Modifications to the Collar for the
Vertically Split Yoke SSC Collider Dipole Magnet

Jim Strait
Fermilab
19 July 1990

Figure 1b

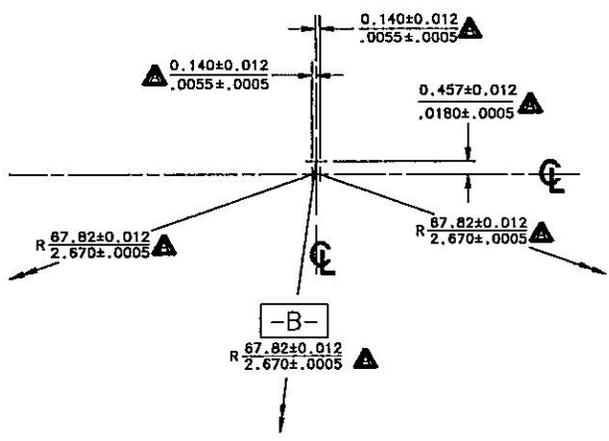
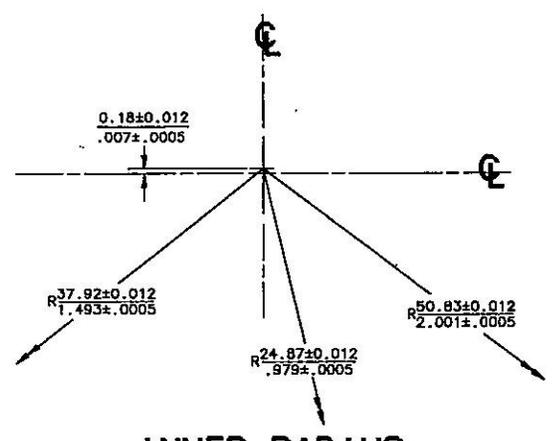
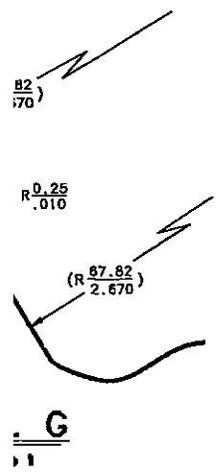
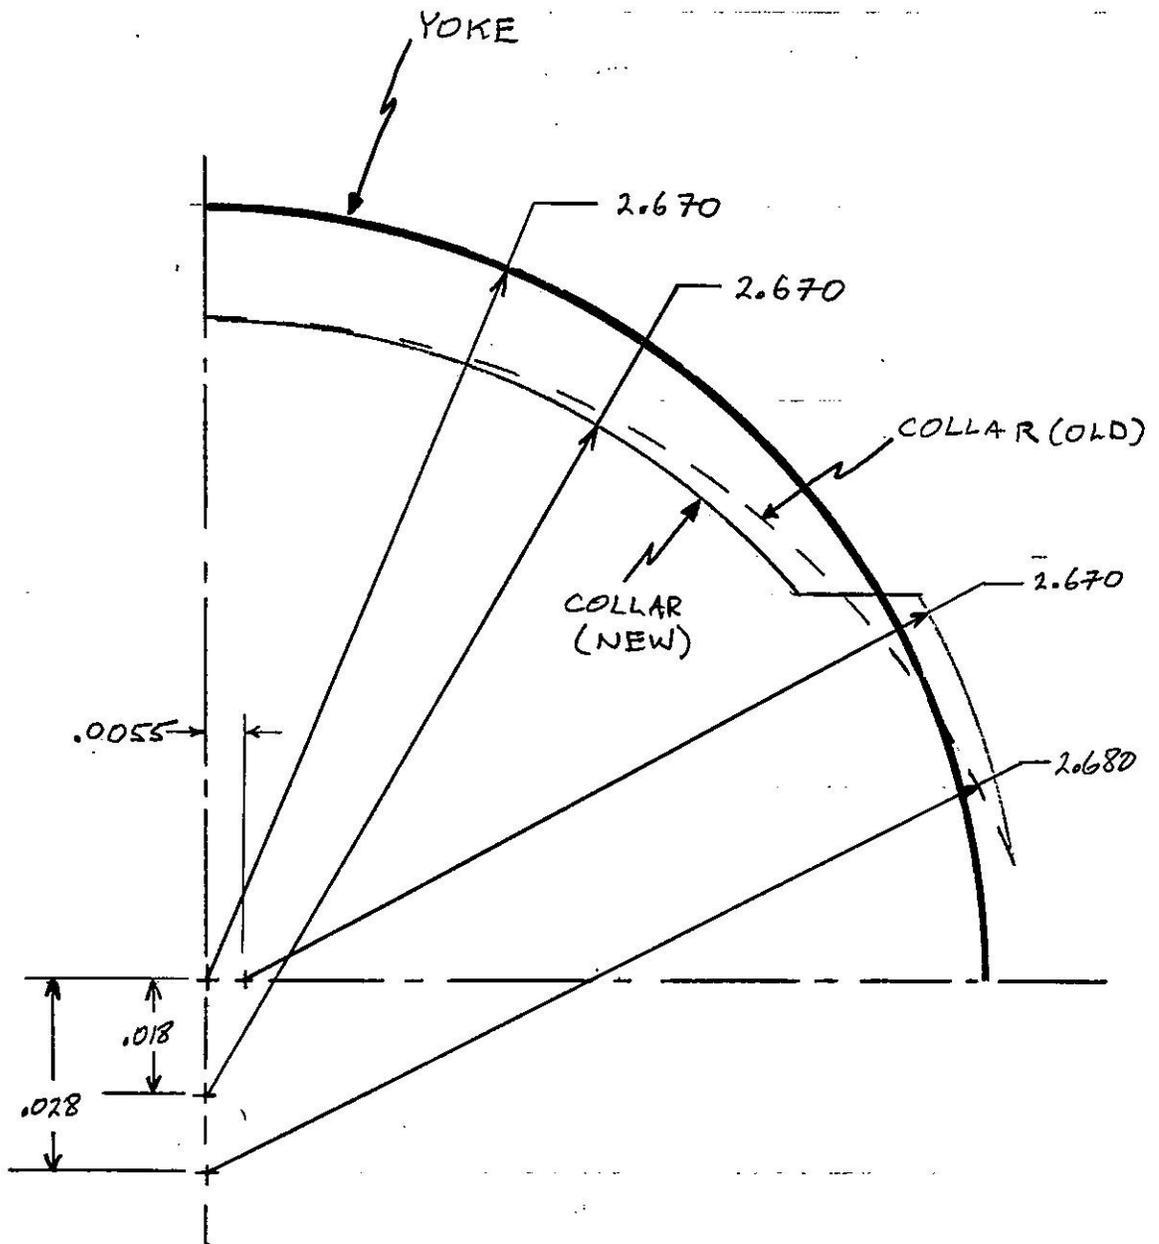
The yoke-collar interface design calls for 5.5 mils of radial horizontal interference and 18 mils of vertical clearance between the yoke and the (undeflected) collar. In Ref. 1 this was accomplished by setting the collar radius to 10 mils larger than the yoke radius and offsetting its center down by 28 mils. This is represented by the dashed line in Fig. 2. (The collar is drawn only above 10° because the collars are designed to clear the yoke in the in the region of the keys.) As is clear from this figure and from Fig. 3 in Ref. 1, this shape will give a non-uniform stress in the yoke-collar contact area and the stress just above 10° may be very large. The new design has the radius of the outer surface of the collar equal to the yoke radius, but between 10° and 30° the center is shifted to the right by 5.5 mils and between 30° and 90° the center is shifted down by 18 mils. This is represented by the lighter solid line in Fig. 2. The maximum skin tension required to close the mid-plane gap is 24 kpsi [1], implying a maximum yoke-collar force of $24 \text{ kpsi} \times 0.188" = 4500 \text{ lbs/in}$. The arc length of the contact region is 0.93". Assuming a 50% die break for both the yoke and the collar, the actual contact area is about 25%. Thus the maximum contact stress is approximately 19 kpsi, well below the 40-50 kpsi yield of the yoke material. At 4 K and 8 T, the maximum yoke-collar force is about 6400 lbs/in, giving a contact stress of about 27 kpsi. In the original design the area of contact was approximately one-half as large and the contact was very non-uniform, resulting in the possibilities of local yielding.

The pole angle of the outer coil has been modified slightly following a suggestion by Ramesh Gupta (see attached e-mail) to set $b_2 = 0$. After the cross section was "fixed" and a considerable amount of tooling and parts had been ordered, particularly at BNL, the final dimensions of the cable were set at values slightly different from those assumed in the magnetic design. In particular, the inner cable width increased by 9 mils from the original design and by 6 mils from the first samples and the outer cable thickness was decreased by 0.4 mils. The increased inner cable width was handled by keeping the inner coil outer radius and pole angles fixed and reducing the inner radius by 9 mils. We (FNAL) had decided to handle

the decreased outer cable thickness by leaving the the mold and collar dimensions the same and counting on the epoxy to fill the extra 0.4 mils between cables. This would result in no change in the harmonics generated by the outer coil. BNL has apparently decided to mold the coil to a smaller size to maintain the same amount of turn-to-turn epoxy and add a 10 mil shim at the outer coil pole. Gupta has calculated the that the FNAL solution gives $b_2 = -1.0$ unit and the BNL solution gives $b_2 = +1.3$ units. The intermediate situation, adding a 5 mil shim, gives $b_2 = 0.2$ units and decreases the amount of "extra" turn-to-turn epoxy to 0.2 mils. We have now adopted this solution by moving the collar pole surface by 5 mils. (We also have a version of the collar which was designed to use a 25 mil pole shim on both the inner and outer coils; it now calls for a 30 mil outer coil shim.)
